Modification application MP 06_0094 Mod 5 was submitted to the Department of Planning, Industry and Environment (the Department) in October 2018, seeking to facilitate changes to the Sandon Point Concept Plan on the Anglicare (formally Anglican Retirement Villages (ARV)) lands within the Sandon Point Precinct.

The Applicant, and the specialist consultant team have reviewed and considered the matters raised by the Department, other government agencies and the public submissions. This report sets out the Applicant's response to the key issues raised, details the final project including a number of clarifications and minor revisions to MP 06_0094 Mod 5. A detailed table setting out a response to each of the submissions received is provided at **Appendix A**.

This PPR/RtS addresses the issues raised and additional information requested during the public exhibition of Modification 5 to the approved Sandon Point Concept Plan. A detailed response to submissions is provided at **Appendix A** with further detailed technical advice provided in the relevant technical reports.

Figure 2: Proposed modified Concept Plan

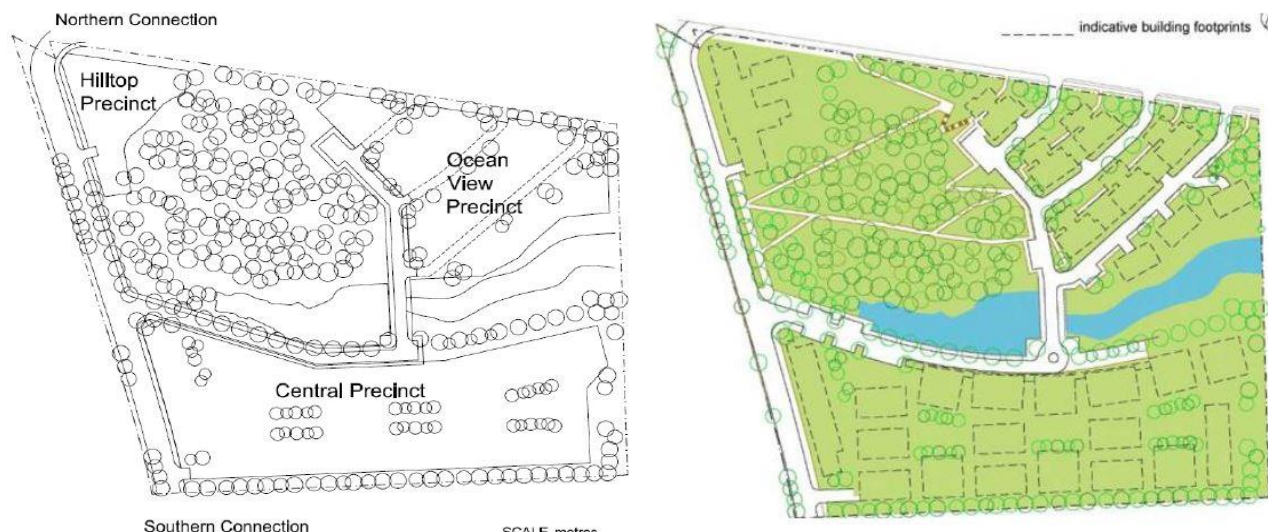
The Department raised concern with respect to the number of lots proposed along Wilkies and Geraghty Streets. In response to this the Concept Plan has been amended (refer to **Figure 2** and **Appendix B**) such that:

- The number of dwellings in Precincts 2 and 3 has been reduced by three and one respectively, resulting in an overall reduction of dwellings from 55 to 51;
- The number of vehicular crossings providing direct access to dwellings along Geraghty and Wilkies Streets have been significantly reduced thereby reducing the potential for pedestrian/vehicular conflicts and improving pedestrian safety. Access to these dwellings will now be provided from the internal perimeter roads; and
- Cooksons Creek is no longer required to be diverted and views towards the Turpentine Forest are increased.

The level of detail provided on the modified Concept Plans is now consistent with the detail shown on the approved Concept Plans as shown in the comparison of **Figure 1** and **Figure 2** below. The key changes to the Concept Plan design following receipt of the submissions are detailed within **Section 3.0**.

Refer to the amended Concept Plan at **Appendix B** and **Figure 2** above.
